LYNDA CORRIE ESTATES SUBDIVISION, **RESUBDIVISION OF**

APPLICATION NUMBER 26 DATE October 18, 2007

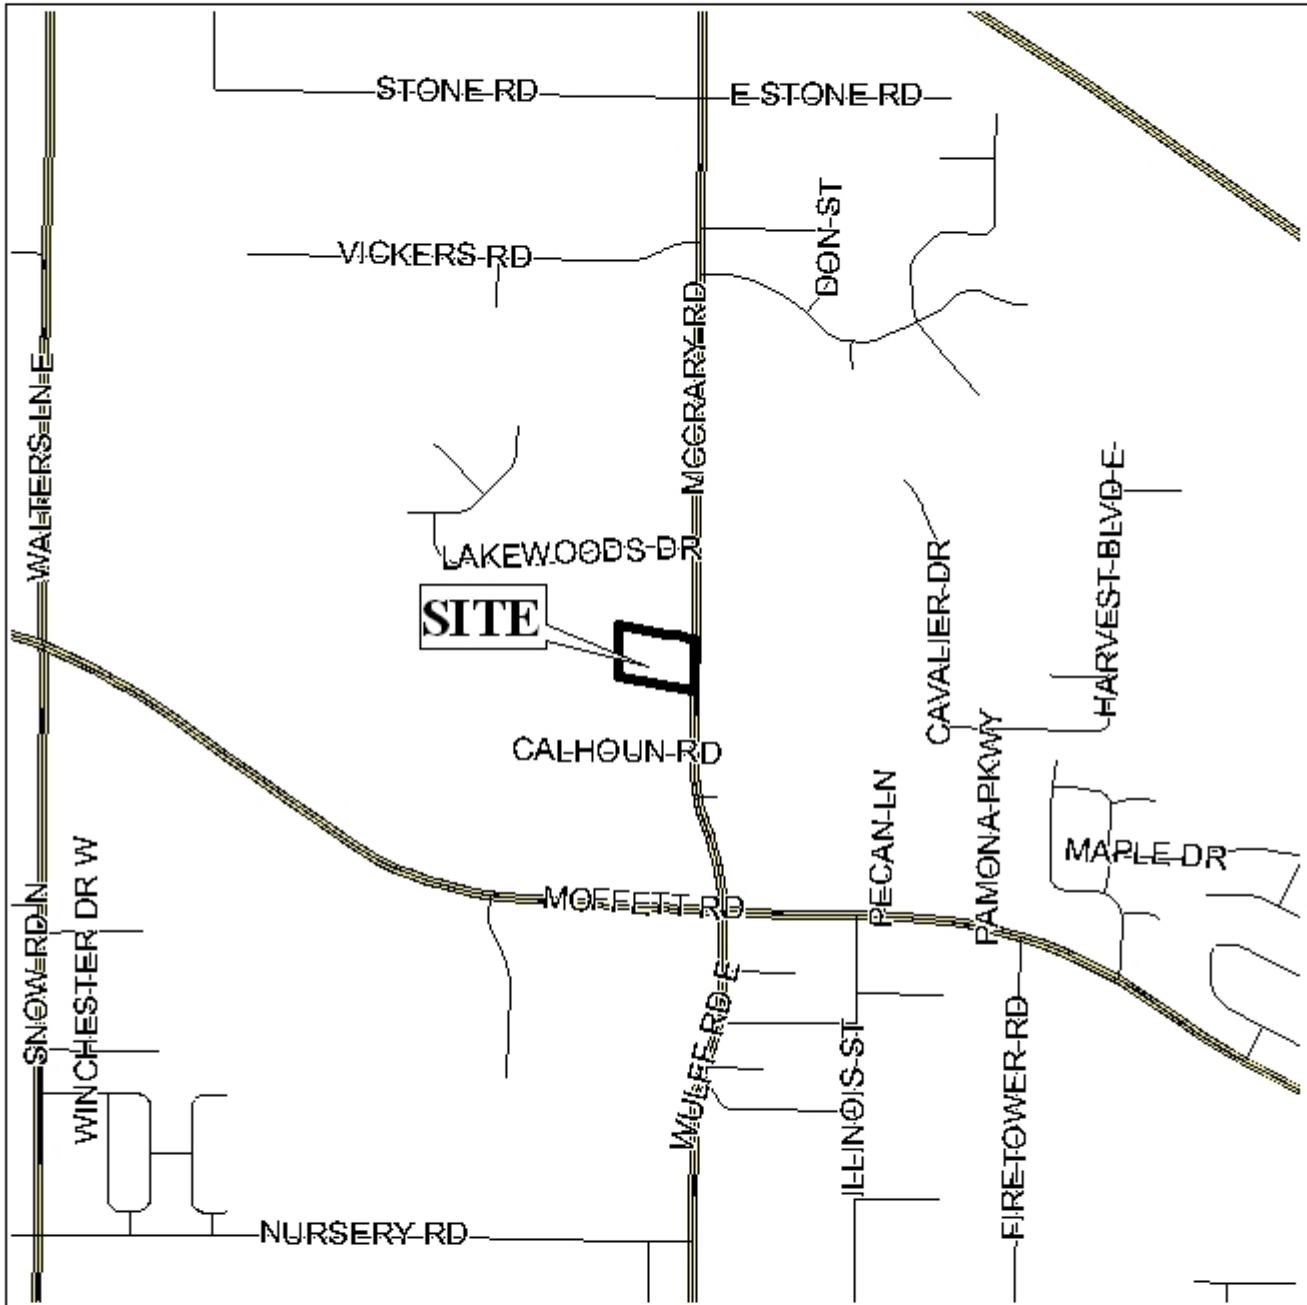
The plat illustrates the proposed 3-lot, 6.12 \pm acres subdivision which is located on the West side of McCrary Road, 500' \pm North of Calhoun Road. The subdivision, which is located outside the Mobile City Limits, is served by public water and individual septic systems.

The site has road frontage on McCrary Road, a planned major street, and the existing right-of-way is shown as 80'. The Major Street Plan requires a 100' right-of-way; therefore, the provision of a 75' setback (which includes the required minimum building setback of 25'), from the centerline of McCrary Road, to provide for the right-of-way of the planned major street should be required. Lot 3, a "flag lot" would also require a 25' minimum building setback line from its front, or East line common with Lots 1 and 2. Additionally, as a means of access management, a note should be placed on the final plat stating all lots are limited to one curb cut each to McCrary Road with the size, location and design to be approved by Mobile County Engineering.

No lot sizes in square feet were indicated on the plat; therefore the final plat should be revised to label each lot with its size in square feet, or a table depicting the same information should be provided.

Inasmuch as the original two-lot subdivision was approved with one lot exceeding the depth-to-width ratio of Section V.D.3. of the Subdivision Regulations, Lots 1 and 2 of the proposed resubdivision would both exceed that ratio and would not be characteristic of the area. Also, Lot 2 would be a “flag lot” not characteristic of the area per Section V.D.1. of the Subdivision Regulations.

- 1) Lots 1 and 3 would exceed the depth-to-width ratio of Section V.D.3. of the Subdivision Regulations; and
- 2) Lot 3 would be a “flag lot” and would not be characteristic of the area, per Section V.D.1. of the Subdivision Regulations.
